1 Dunollie Road, London, NW5 2XN

Basement Impact Assessment Audit

London Borough of Camden

Project Number: 13398-05

Lightwell Retaining Wall Calculations

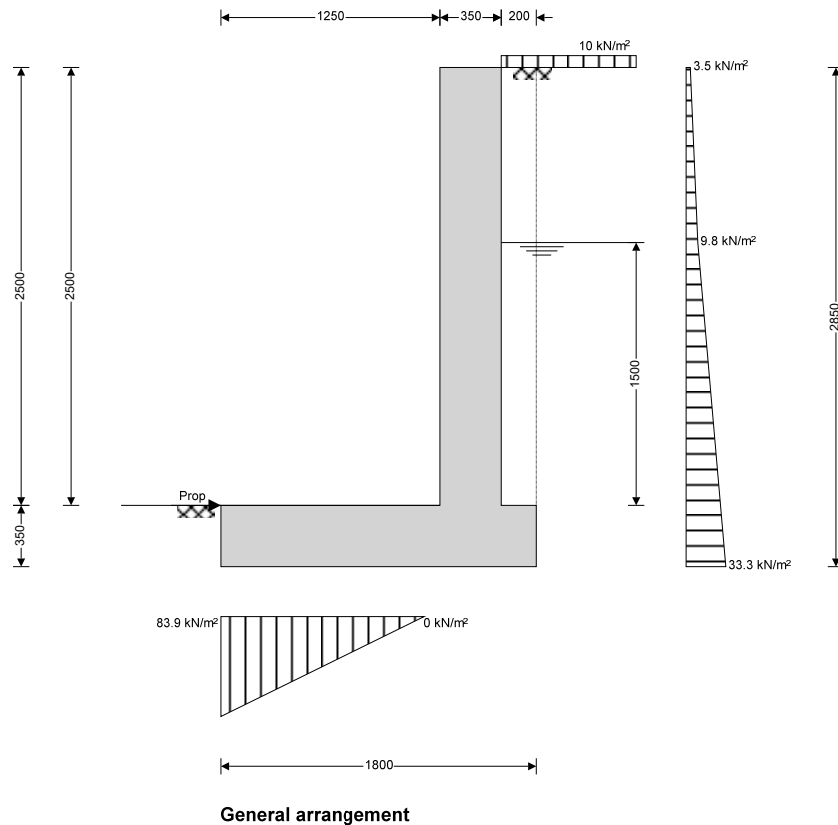
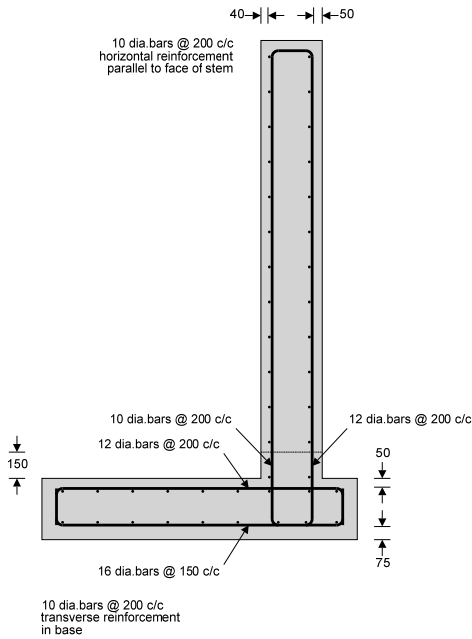
- 4.14. Appendix A of the Croft BIA presents structural calculations for the basement wall. Clarification is required regarding the use of a 200mm long heel in the general arrangement of the retaining wall design. The subsequent structural drawings presented in Appendix D do not show a heel to the retaining wall. Drawings, calculations and the construction methodology should all be consistent. **Please refer to attached document "lightwell retaining wall revised Ka&Kp values". The design presented is the worst case which is for the lightwell to the front.**
Please refer to attached document "190611 A3 PL-10" for a revised drawing to show the heel to the front. The section shown is taken from side to side

Job Number 190611	Date July '19
Dwg Number TW-11	Rev 1
Drawn SB	Chkd EP
Scale As shown @ A3

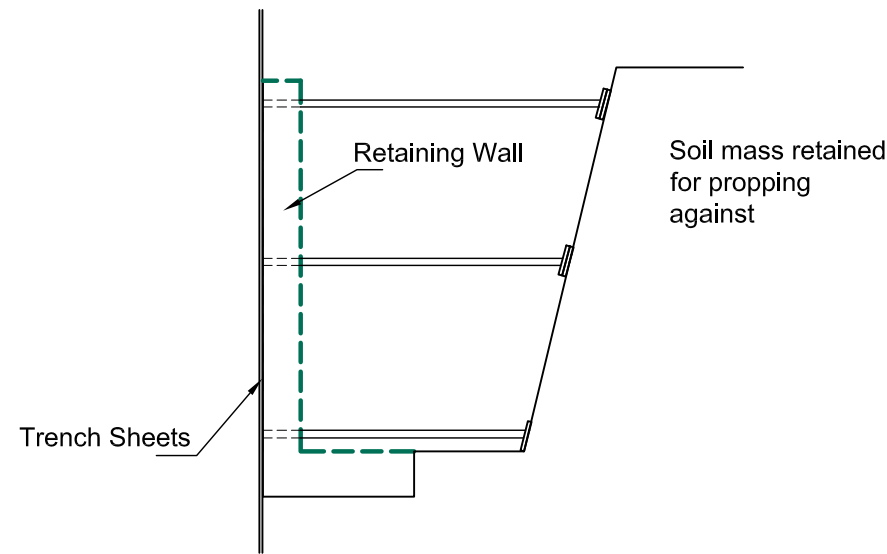
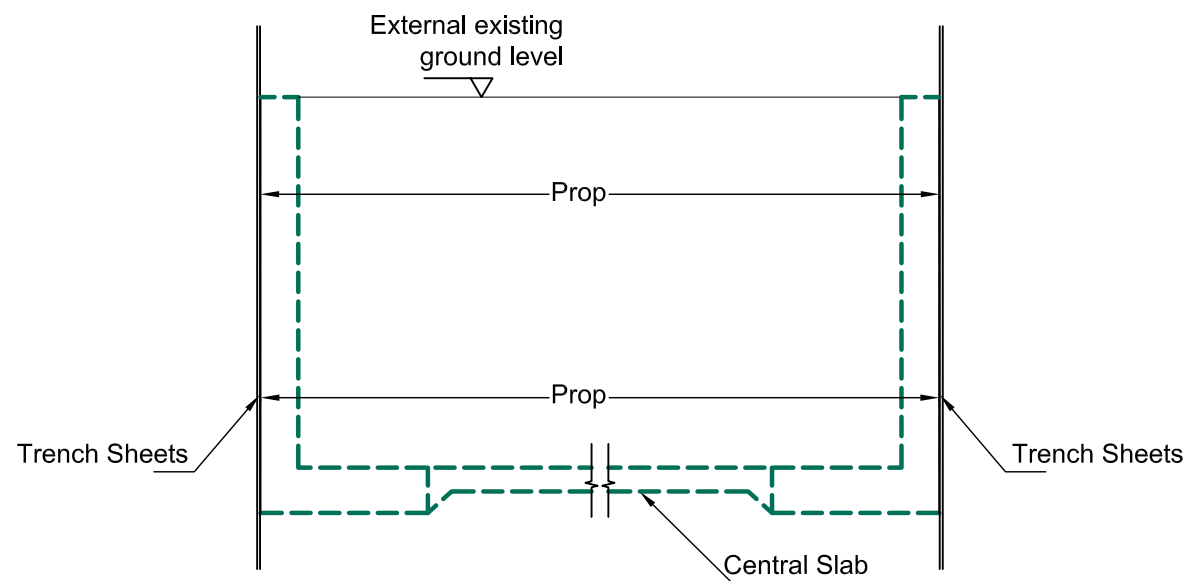
- 4.11. Structural drawings and a temporary works sequence, presented in Appendices D and E of the Croft BIA, indicate mass concrete underpinning beneath the party wall with No 1 Dunollie Road. An RC wall is to be constructed inside the underpinning along that side. Elsewhere an RC wall is to be constructed in an underpinning type sequence. Excavation for the construction of the basement walls is to take place on a hit and miss basis with the excavation faces supported by trench sheeting. The central soil dumping is to be excavated once the retaining wall is complete.

- 4.12. Section 10.1 of the Maund BIA describes the intention to *'drive trench sheets around the open faces'* and excavate the soil mass before casting a reinforced concrete retaining wall in bays. It notes that the retaining wall is to be cast on a *'sacrificial concrete strip'*. The sequence differs from that described by Croft and, while it does not refer to underpinning, underpinning is discussed later in the Maund BIA. Clarification of the construction methodology for the basement is required. **'sacrificial concrete strip' has been removed from Maund BIA.**
